Product Update Notice

RCS Actuators

MAR1600-65 / MAR 4000-160 Actuators 90 Degree Gear Box Replacement

June 26, 2019

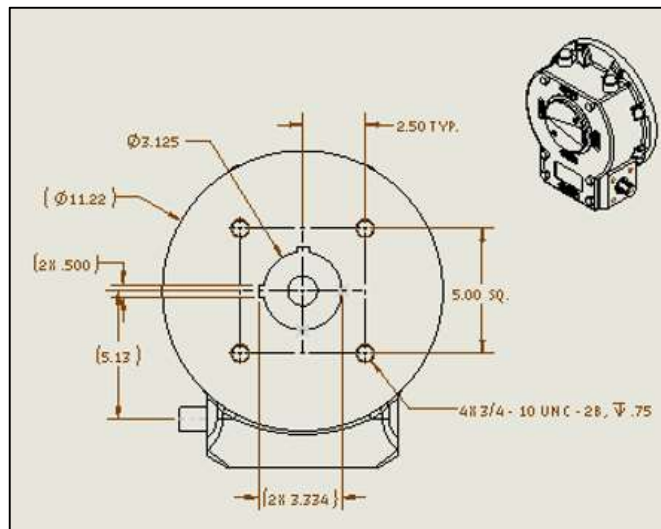
The 1600-65, and 4000-160, are interchangeable with old units, but shaft diameter has changed from 3.25" to 3.125". This will require a new, or modified coupling.

92-15 Gearbox assembly 90 degree is replacing current gearbox for 1600-65 and 4000-160 actuators. As offered by current vendor. New actuator/gearbox assembly can replace old units, but it will require a new, or modified coupling. Shaft diameter has changed to 3.125"
